Members of the Board of Park Commissioners,

December 12, 2018

It is not appropriate to approve the James Madison Park Master Plan tonight. Your referral is the appropriate, positive action, reflecting the importance and legacy impact this plan will have on the entire city. As an architect in my 11th year of service on city committees, we are being asked to review an over 200-page document, dated today, that has been compiled over the last year. Prior to its posting on Friday, stakeholders were provided different documents on the website that have been removed. Your 2016 Statement of Policy and Guidelines for Master Plan Activities within the Madison Park System **requires you ensure individual park master plans are consistent with the most recently adopted [City of Madison Park and Open Space Plan](#) and [Comprehensive Plan](#)**. Both plans have been recently updated and adopted, by this Commission at the end of October and by the Common Council in August, respectively. I have found a draft of the adopted copy of the Park and Open Space Plan available online. **This individual park master plan cannot compromise goals in adopted plans of community members citywide.**

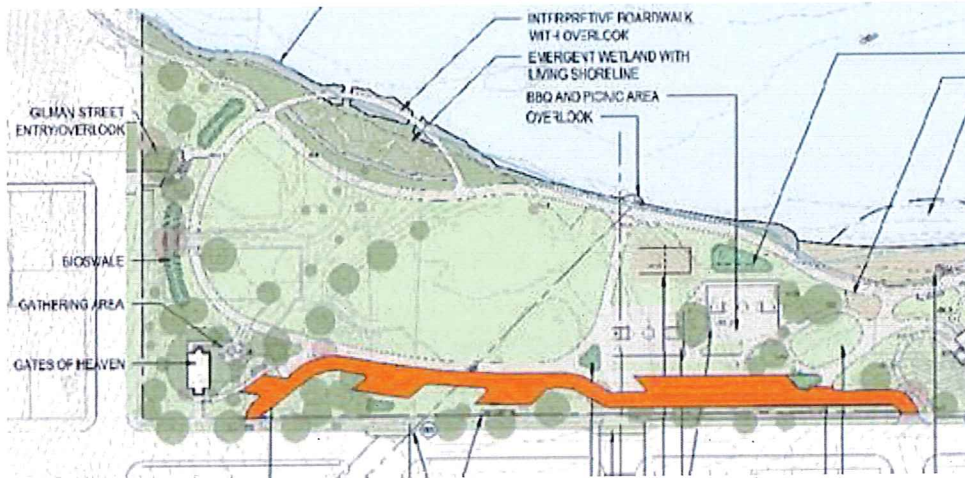
At tomorrow evening's meeting please present your calculations regarding paved surfaces as previously requested by stakeholders on September 12, 2018. Specifically, provide data, and a simple graphic to identify the location of the calculation, that qualifies the statement in the draft report: *"The park master plan expands the large open space on the western half of the park by relocating the double-loaded surface parking lot to the periphery of the park along E. Gorham Street."*

The relocation of the parking further from the lake is also solely credited that it *'increases the amount of uninterrupted open space by a few hundred square feet'*.

I completed a conservative calculation based on the September 24, 2018 draft master plan areas graphically identified below. **The parking lot design results in a REDUCTION of uninterrupted green space. The proposed uninterrupted green space is REDUCED TO LESS THAN 70% of the current uninterrupted green space.**

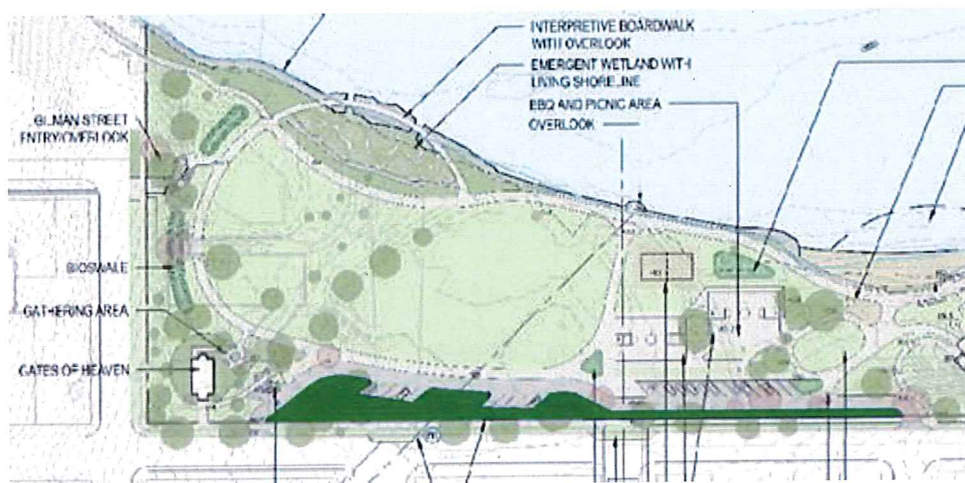
2. Provide the area of the proposed parking lot surface. 26 parking stalls were indicated in September, the draft report reflects a count of 27 stalls.

- The area of the proposed parking lot surface is approximately 20,600 s.f. for 26 parking stalls.

3. Provide the area of greenspace along Gorham being severed from uninterrupted greenspace by the new parking lot.

- The area of greenspace along Gorham being severed from uninterrupted greenspace by the new parking lot is approximately 14,890 s.f.

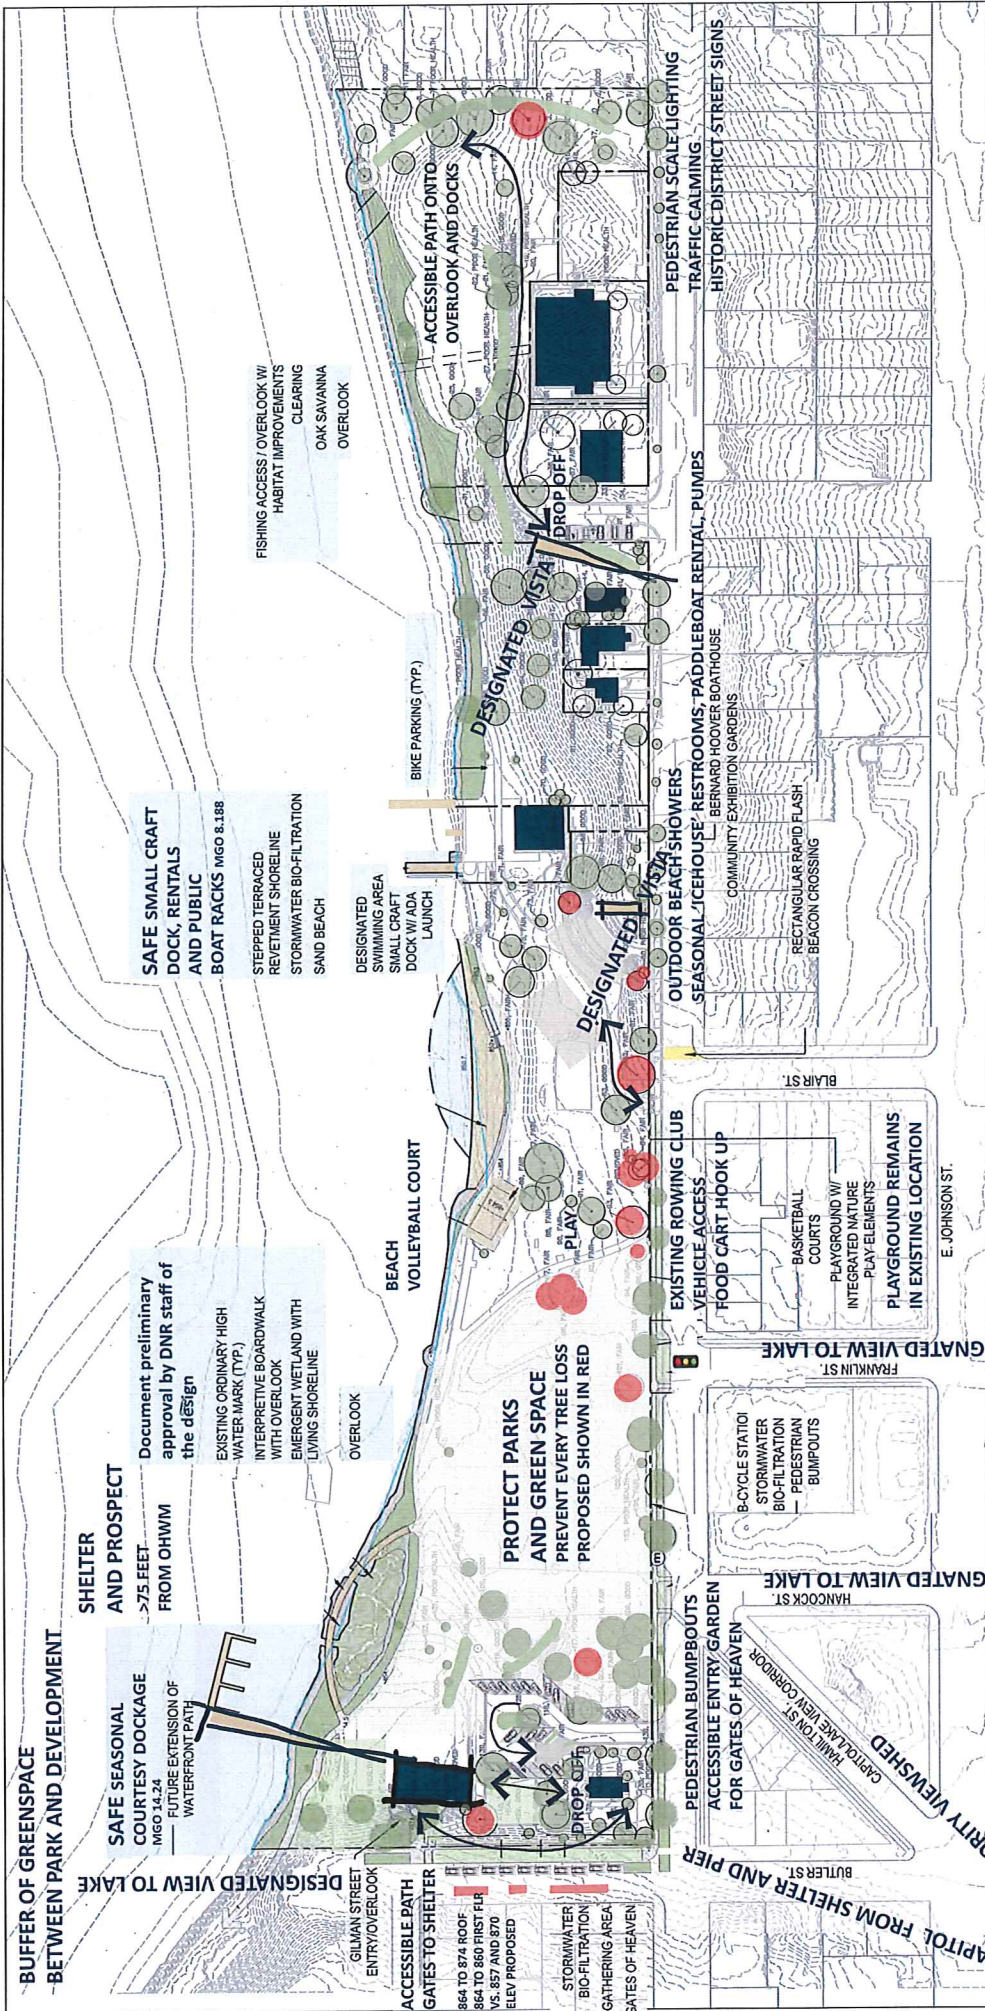
BUFFER OF GREENSPACE BETWEEN PARK AND PARKING OR DEVELOPMENT

DEFINE PROCESS TO ACQUIRE GREENSPACE TO OFFSET FUTURE POTENTIAL HISTORIC HOME RELOCATION

UNIVERSAL ACCESSIBILITY SEAMLESSLY INTEGRATED

- Criteria:
1. Adequately confirm information. Data provided does not support several misleading statements in the draft report.
 2. Meet the scope of this master plan process requirements. All budgetary decision-making, provide a framework for implementation.

3. Ensure consistency with the most recently adopted Tenney-Jaham Neighborhood Plan, Parks and Open Space Goal 4: Protect parks and green spaces from encroachment by public infrastructure such as parking lots and paved areas. Add buffers of green space when parcels next to parks are developed or become available for public purchase.

4. Ensure consistency with the most recently adopted City of Madison Comprehensive Plan, Preserve defining views of the lakes, downtown skyline, and Capitol from publicly accessible locations. "Some of these views are shorter, more intimate views of the lake that reinforce people's connection to nature and the city, but all of these views are important. Once they are lost, they are impossible to recover."

5. Ensure consistency with, and make available to the public, the most recently adopted City of Madison Park and Open Space Plan.
 6. Strive to meet City of Madison Ordinance 8.35 PRESERVATION OF SHORELINE PARKS (2016) Construction which when construction is occurring being covered by buildings, structures and existing buildings, structures and paved areas of less than five percent (5%) of the public park in which the construction is occurring being covered by buildings, structures and paved areas; and, A total, including previously existing boat docks, piers and buildings or structures extending into or over the water, of less than ten percent (10%) of the shoreline of the park in which the construction is occurring being covered by buildings, structures and paved areas.

7. Integrate ADA-compliance into the design process. "Avoid 'segregation' by integrating ADA accessibility seamlessly throughout the park. Exceptionalism is present when ADA accessible amenities are significantly different or separated from other amenities. For example, providing one or two ADA-accessible picnic tables rather than making all park tables ADA accessible, or designing access, viewing, and seating areas such that a person with a disability would have to be separated from companions without disabilities in order to use the amenity."
